**LR-N03-0092
LCR S03-03**

**REQUEST FOR CHANGE TO TECHNICAL SPECIFICATIONS
EXPLOSIVE GAS MIXTURE
SALEM GENERATING STATION UNITS 1 AND 2
FACILITY OPERATING LICENSES NOS. DPR-70 AND DPR-75
DOCKET NOS. 50-272 AND 50-311**

**SALEM NUCLEAR GENERATING STATION, UNITS 1 AND 2
FACILITY OPERATING LICENSES DPR-70 AND DPR-75
DOCKET NOS. 50-272 AND 50-311
REVISIONS TO THE TECHNICAL SPECIFICATIONS**

3.11.2.5 The concentration of oxygen in the waste gas holdup system shall be limited to less than or equal to 2% by volume.

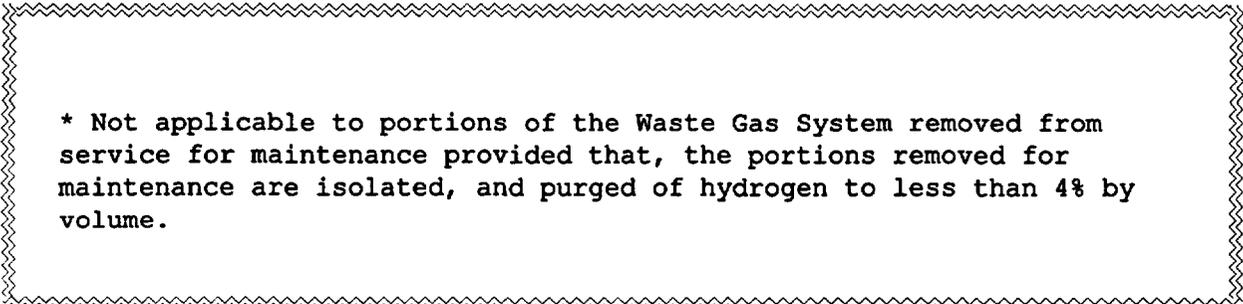
4.11.2.5 The concentration  of ~~hydrogen and~~ oxygen in the waste gas holdup system shall be determined to be within the above limits by continuously monitoring the waste gases in the waste gas holdup system with the oxygen monitor required OPERABLE by Table 3.3-13. If hydrogen is not measured, the concentration of hydrogen shall be assumed to exceed 4% by volume.

* Not applicable to portions of the Waste Gas System removed from service for maintenance provided that, the portions removed for maintenance are isolated, and purged of hydrogen to less than 4% by volume.

3.11.2.5 The concentration of oxygen in the waste gas holdup system shall be limited to less than or equal to 2% by volume.

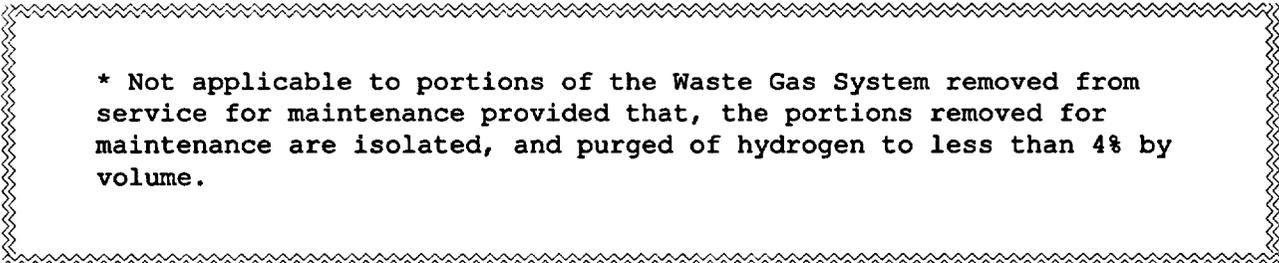
4.11.2.5 The concentration  of ~~hydrogen and~~  oxygen in the waste gas holdup system shall be determined to be within the above limits by continuously monitoring the waste gases in the waste gas holdup system with the oxygen monitor required OPERABLE by Table 3.3-13. If hydrogen is not measured, the concentration of hydrogen shall be assumed to exceed 4% by volume.

* Not applicable to portions of the Waste Gas System removed from service for maintenance provided that, the portions removed for maintenance are isolated, and purged of hydrogen to less than 4% by volume.
